ORDINANCE NO. _____

An ordinance amending Title 30 – Residential Code of the Los Angeles County Code, by adopting the 2016 California Residential Code by reference, with certain changes and modifications.

**FIGURE R403.1.5
STEPPED FOOTING**

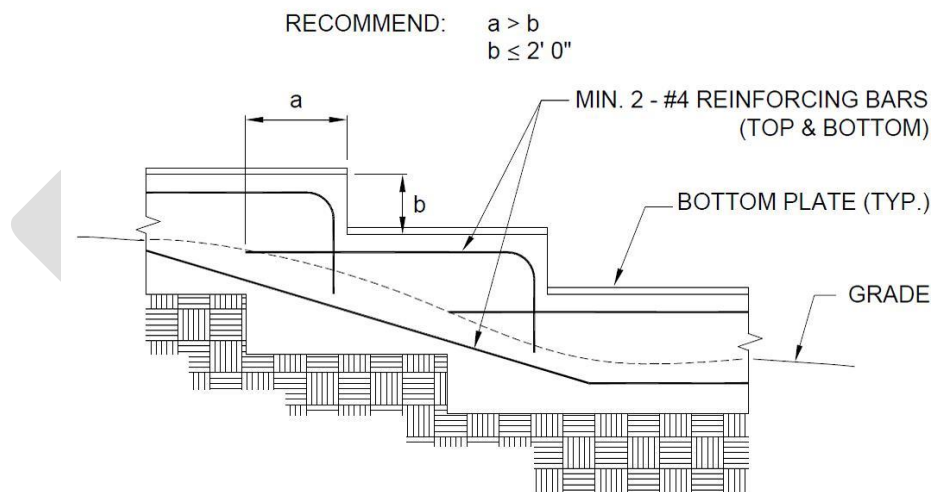
For structures located in Seismic Design Categories D₀, D₁, or D₂, stepped footings shall be reinforced with two No. 4 reinforcing bars. Two bars shall be located at the top and bottom of the footings as shown in Figure R403.1.5.

SECTION 30. Figure R403.1.5 is hereby added to read as follows:

FIGURE R503.2.4

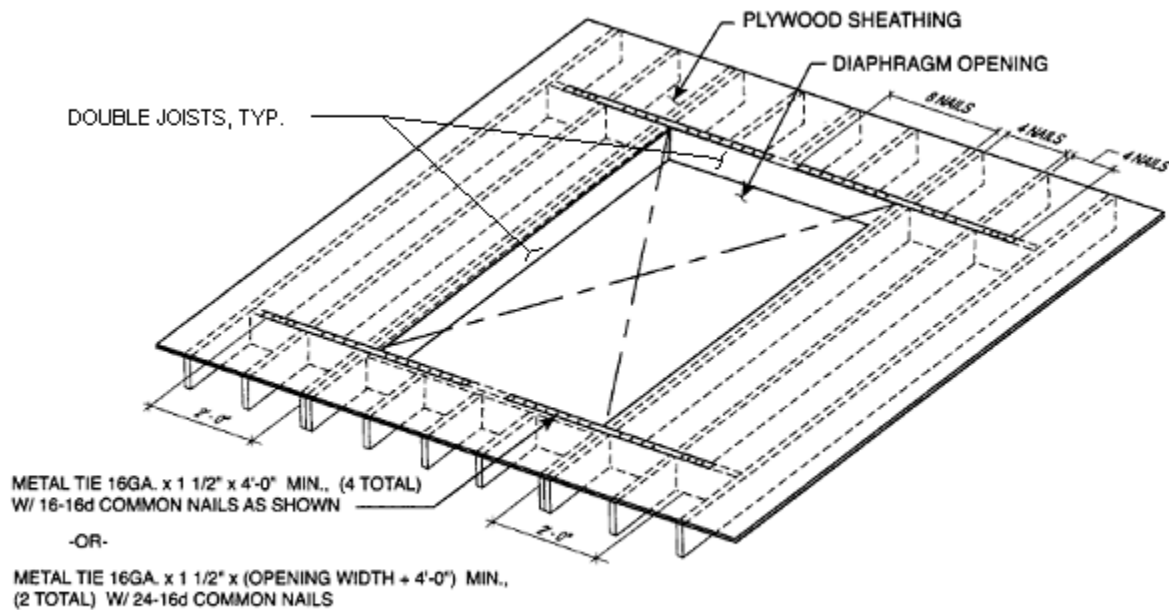
Openings in horizontal diaphragms with a dimension perpendicular to the joist that is greater than 4 feet (1.2 m) shall be constructed in accordance with Figure R503.2.4.

SECTION 34. Figure R503.2.4 is hereby added to read as follows:

- a. Blockings shall be provided beyond headers.
- b. Metal ties not less than 0.058 inch [1.47 mm (16 galvanized gage)] by 1.5 inches (38 mm) wide with eight 16d common nails on each side of the header-joist intersection. The metal ties shall have a minimum yield of 33,000 psi (227 MPa).

c. Openings in diaphragms shall be further limited in accordance with Section R301.2.2.2.5.

FIGURE R602.10.6.1
METHOD ABW—ALTERNATE BRACED WALL PANEL

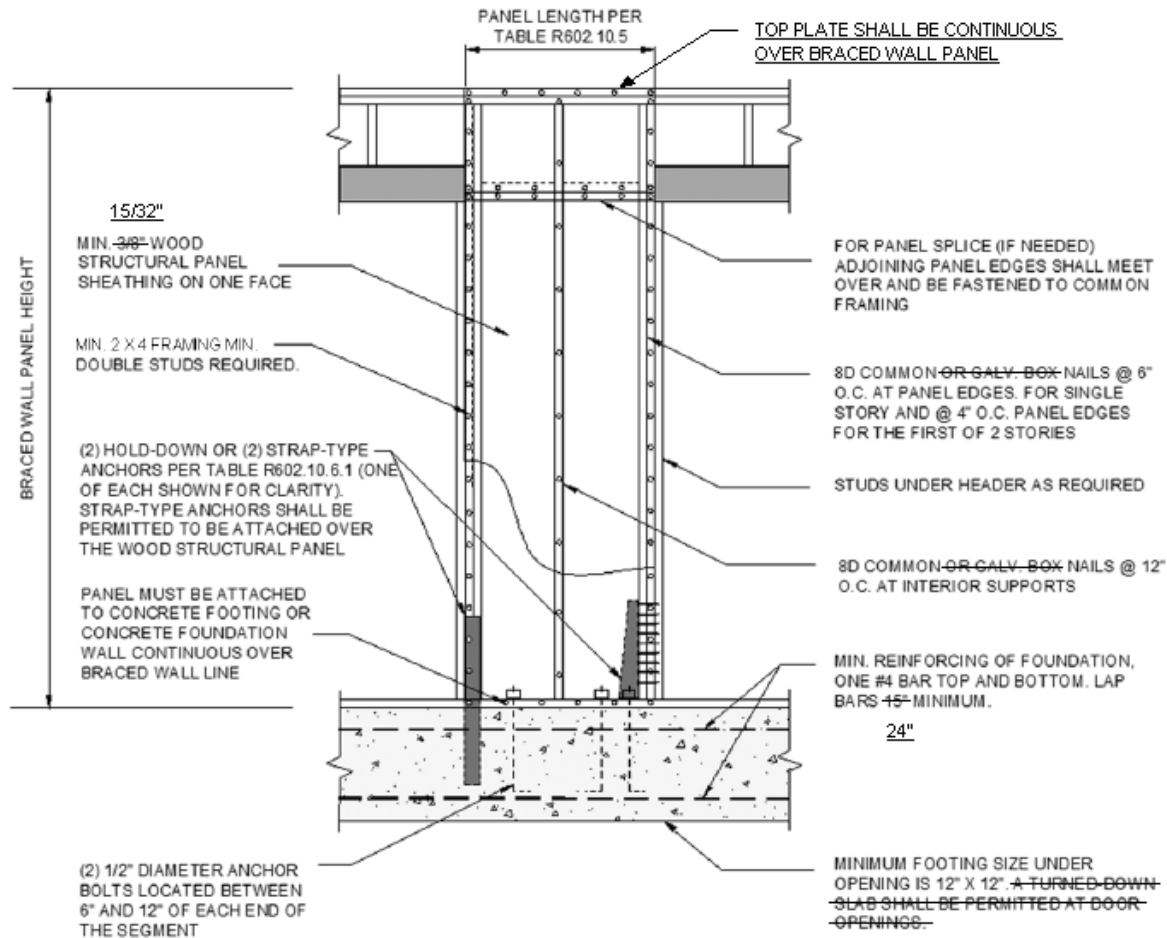
Figure R602.10.6.1 is amended to read as follows:

FIGURE R602.10.6.2
METHOD PFH—PORTAL FRAME WITH HOLD-DOWNS
AT DETACHED GARAGE DOOR OPENINGS

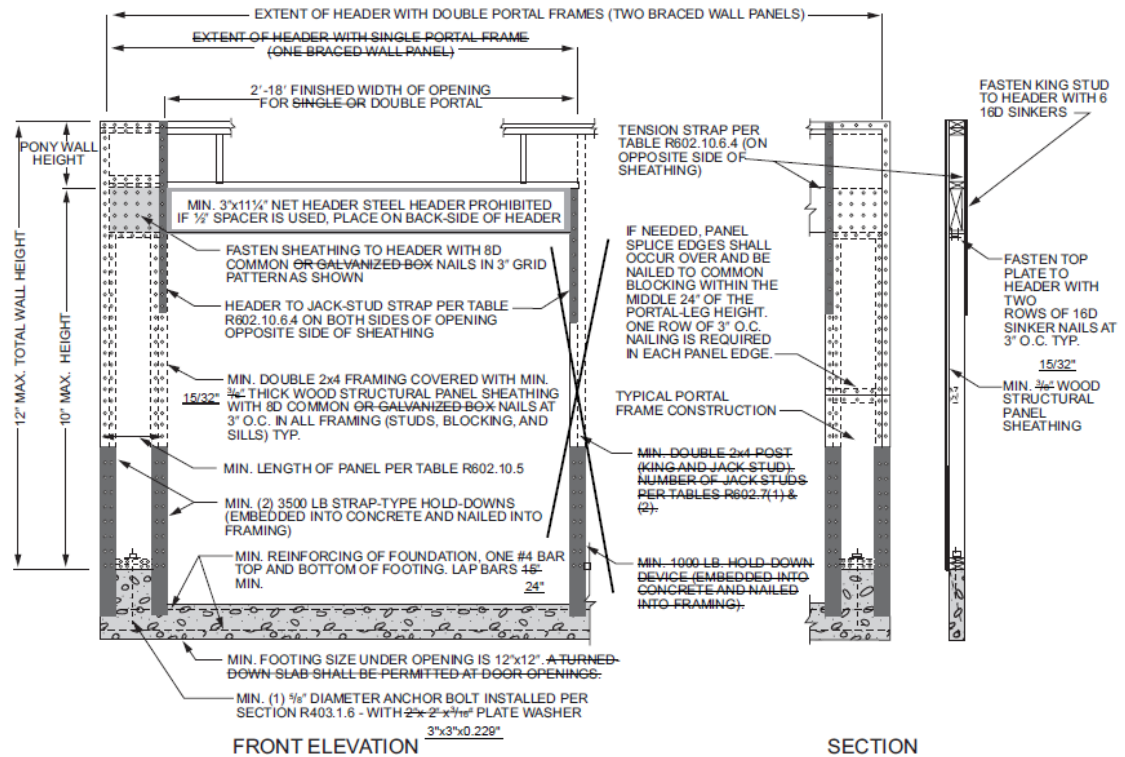
Figure R602.10.6.2 is hereby amended to read as follows:

c. Maximum header height for PFH is 10 feet in accordance with Figure R602.10.6.2, but wall height shall be permitted to be increased to 12 feet with pony wall.

FIGURE R602.10.6.4
METHOD CS-PF-CONTINUOUSLY SHEATHED PORTAL FRAME PANEL CONSTRUCTION

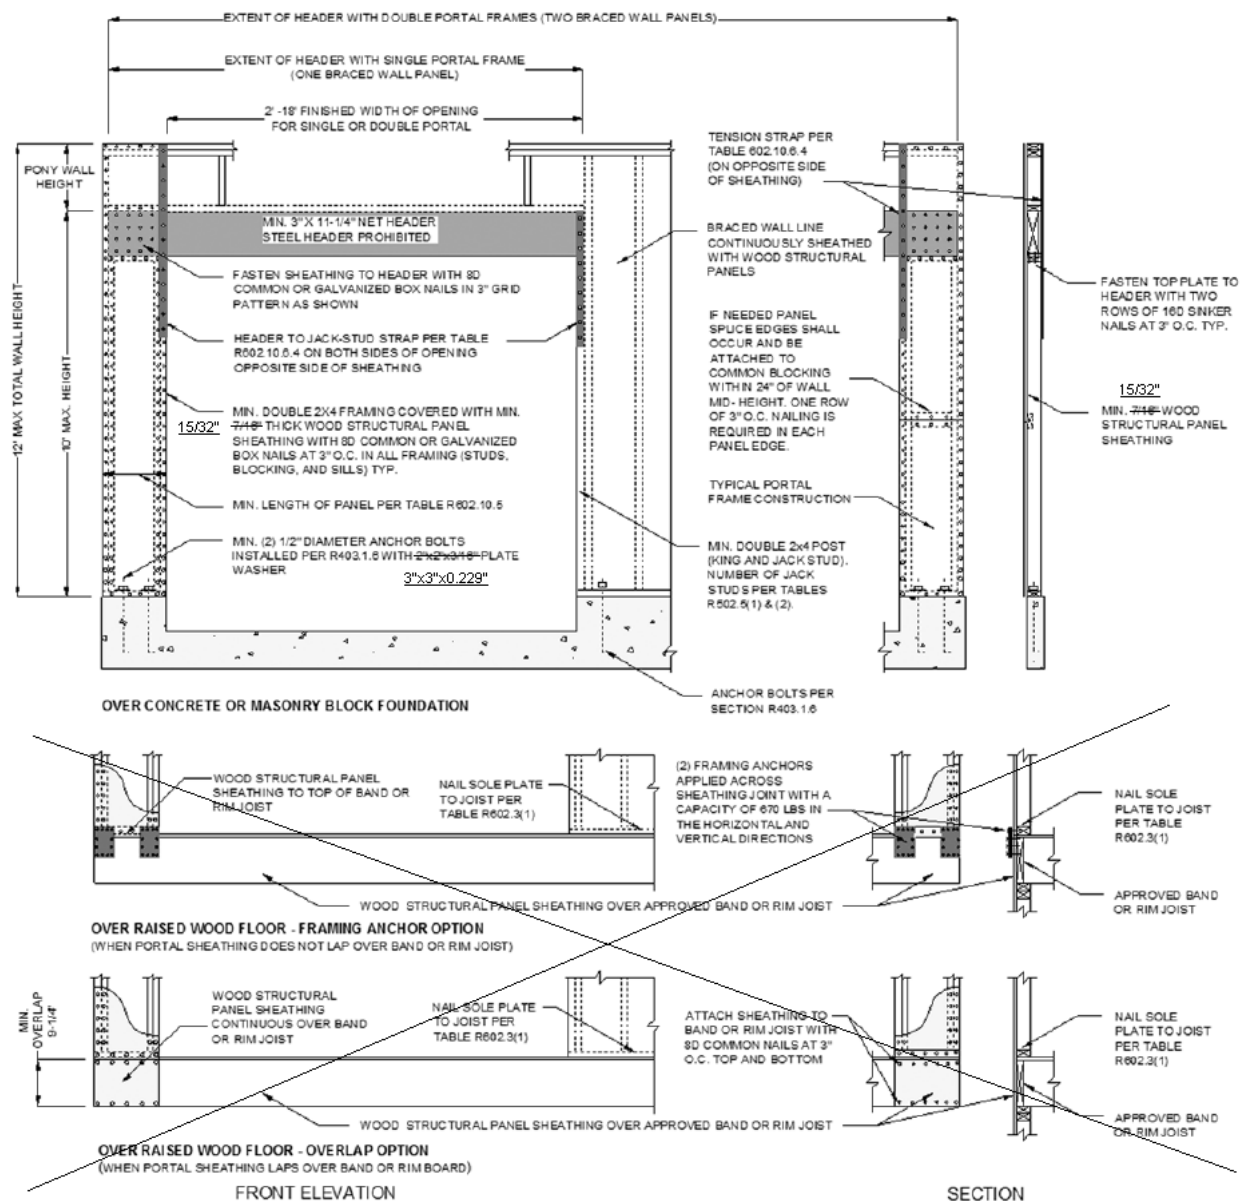
Figure R602.10.6.4 is hereby amended to read as follows:

e. Maximum opening height for CS-PF is 10 feet in accordance with Figure R602.10.6.4, but wall height shall be permitted to be increased to 12 feet with pony wall.
